ALUGRIP - assembly and adjustment

Simplification of AluGrip post assembly. Inform the customer about the correct setting of the AluGrip side pillar locking pin.

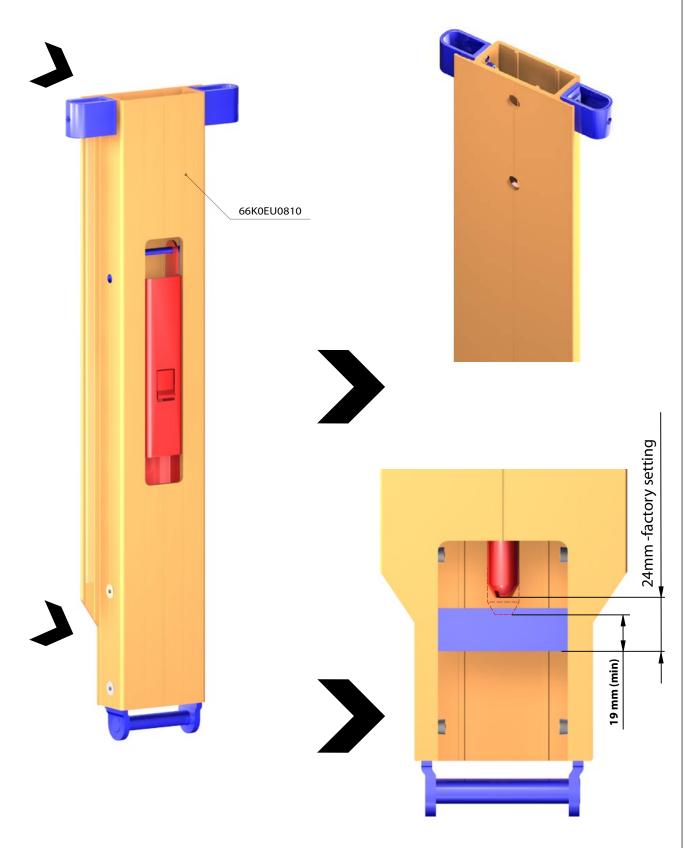
The stability of the column when mounted on the body can be increased by extending the locking pin by up to 5 mm compared to the standard factory setting.

Great force must be applied to loosen the pin.
